FAG BEARINGS CORPORATION

June 30, 1988

Subject: Application for License Amendment to
FAG Bearings Corporation License # 06-20631-01

FIG. 1

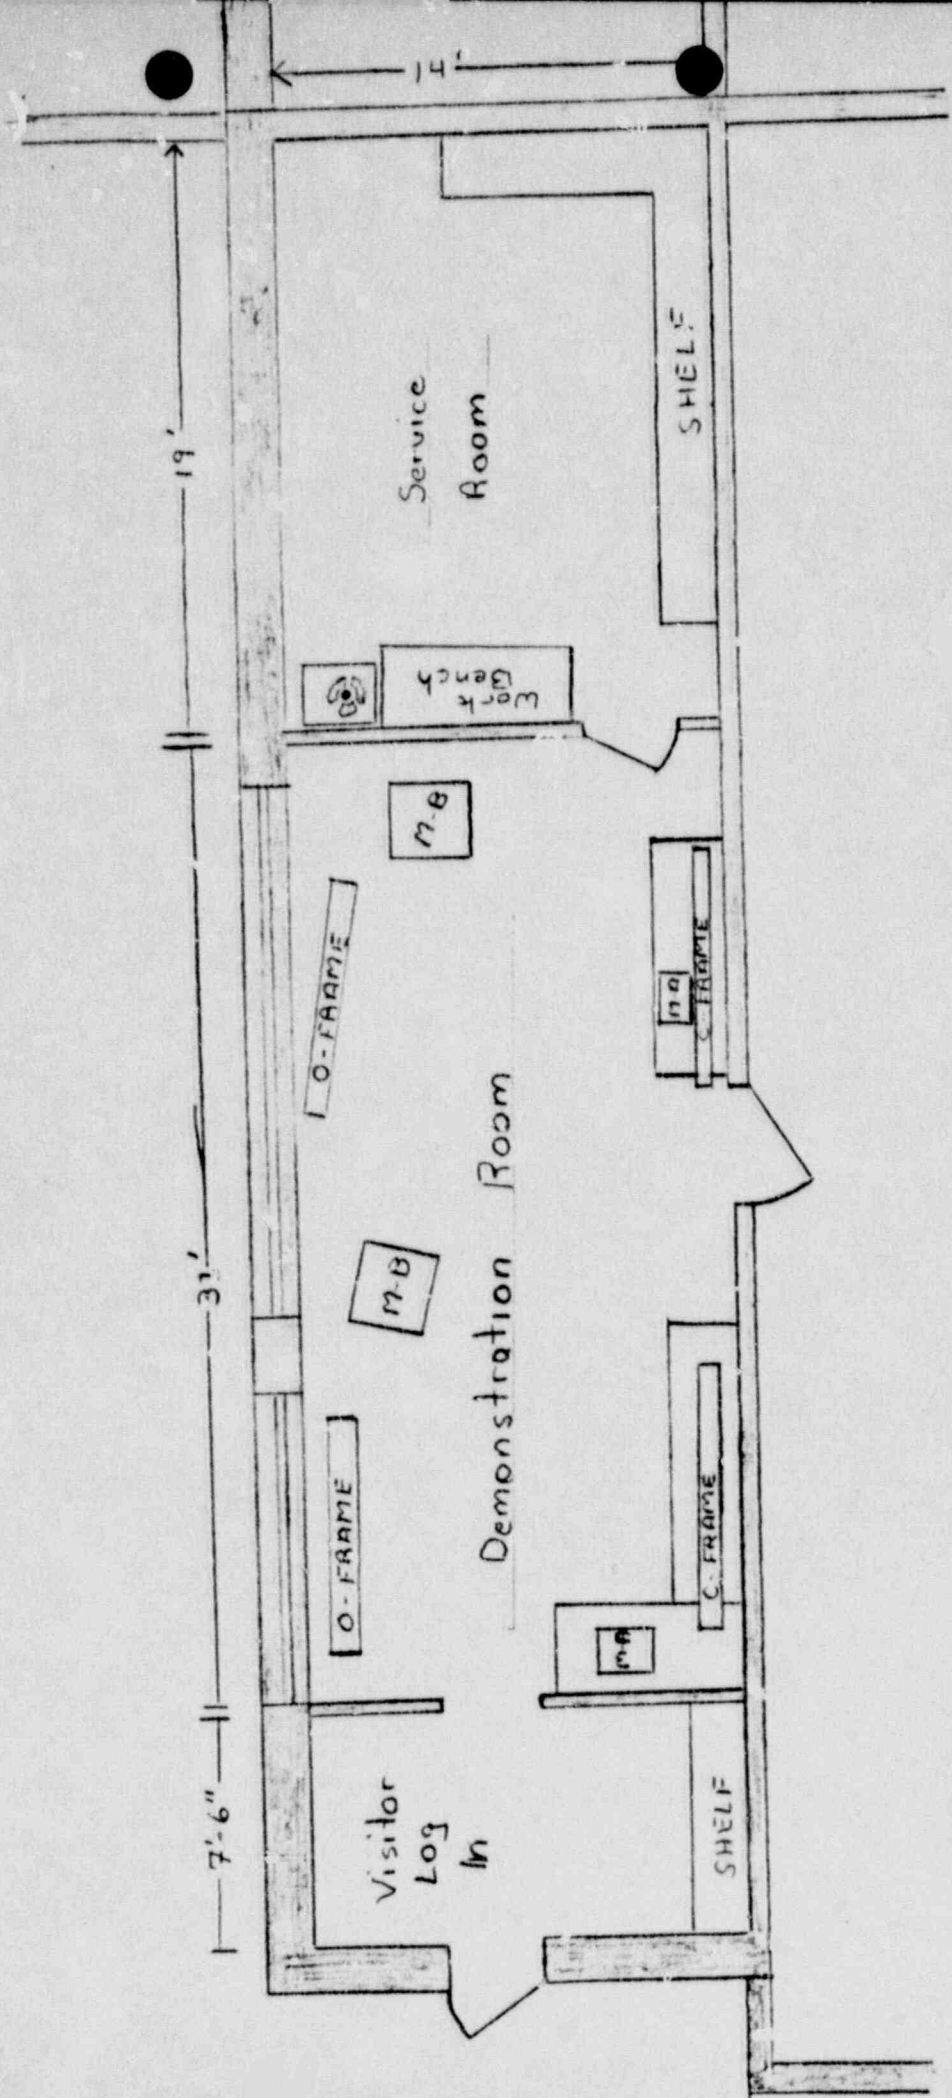
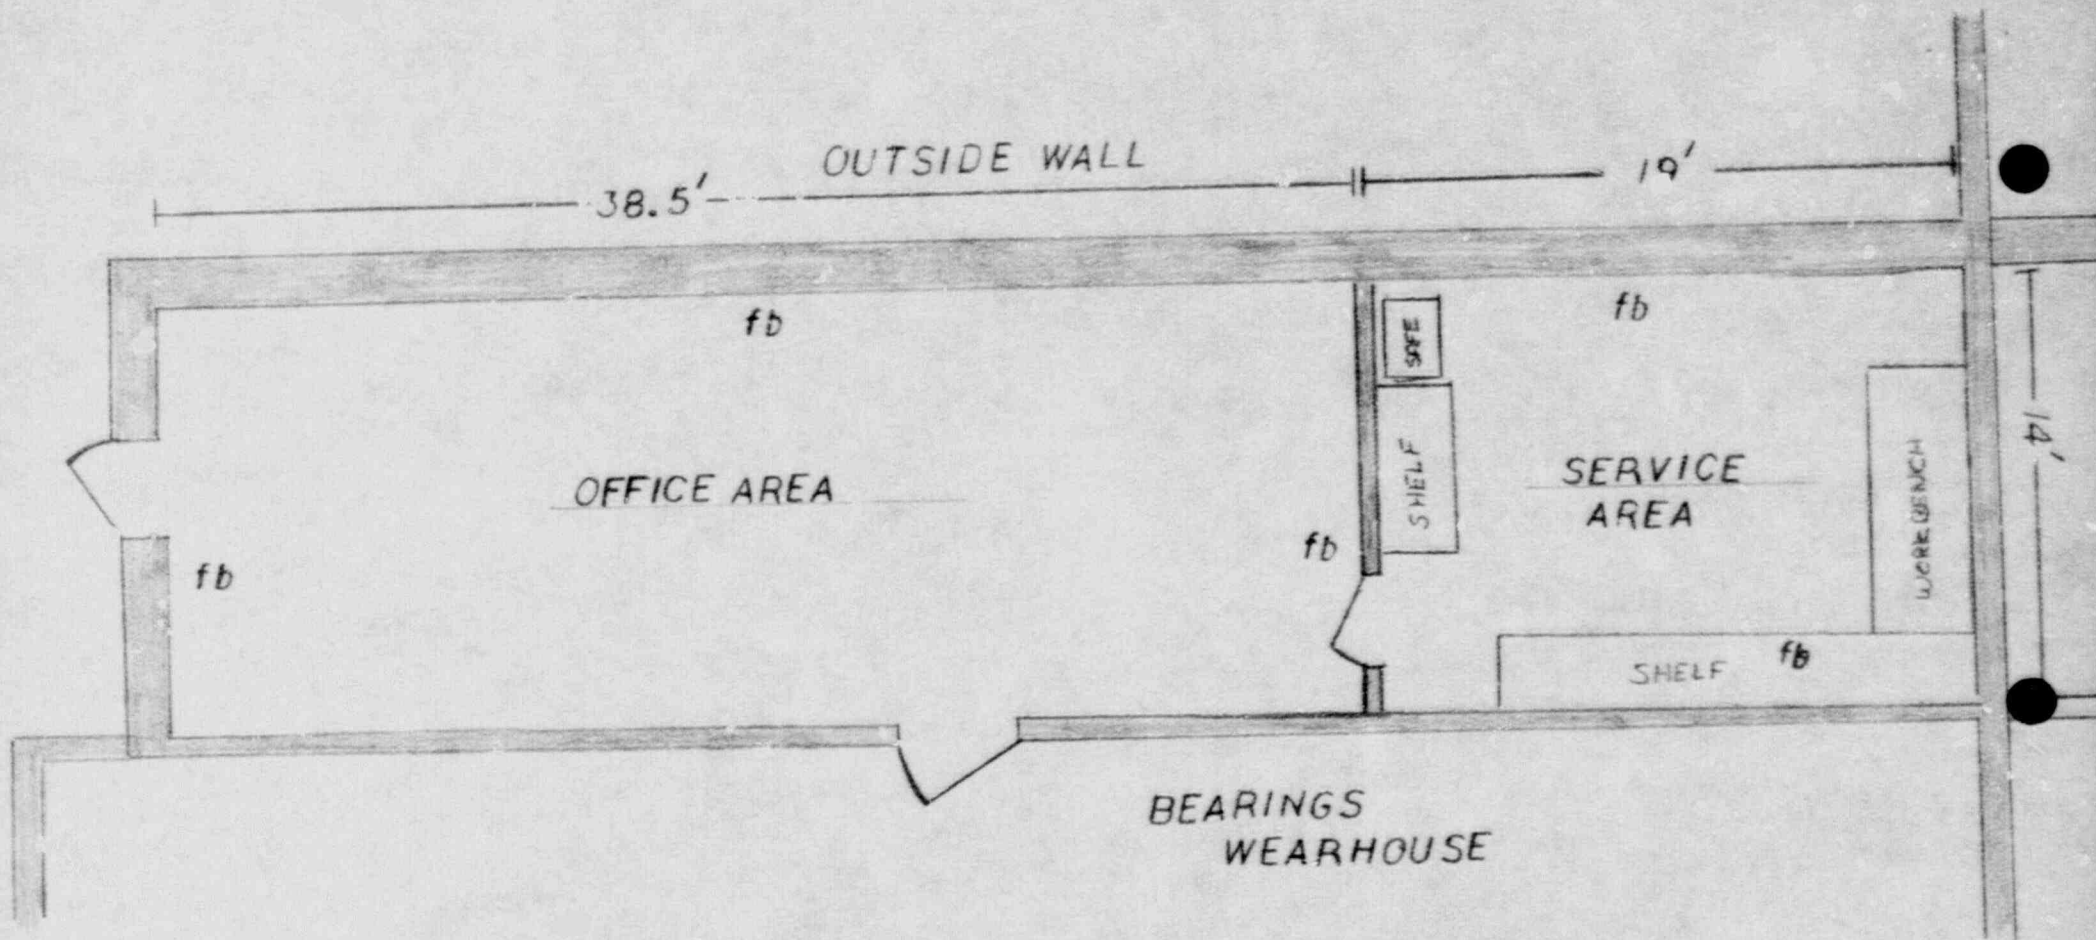
1. The demonstration area of the FAG Gauging facility will no longer contain working gauges, or be used for demonstrations using isotope materials but will be used for office space for the FAG Industrial Gauging staff. The service part of the facility will still be used for servicing gauges and testing sources.

CHANGES TO FACILITY: Figure 1 shows the gauging facility as it had been designed and approved by the NRC in our original license application. The area consisted of a log in area, a demo area and a service area.

Figure 2 shows the new design for the area. The visitor log in area and the demonstration room have been combined into one area to be used as office space. The service area remains and will be used for storage of sources, and other activities as approved under our license.

REASON FOR CHANGE: Experience over the past several years has shown that due to the wide diversity of applications for which FAG gauges are designed, it was very difficult to demonstrate gauges for specific applications at our Stamford facility. Therefore, we have decided that we will no longer demonstrate working gauges at this location. The area which was previously used for gauge demonstrations will now be used as office space for the gauging staff.
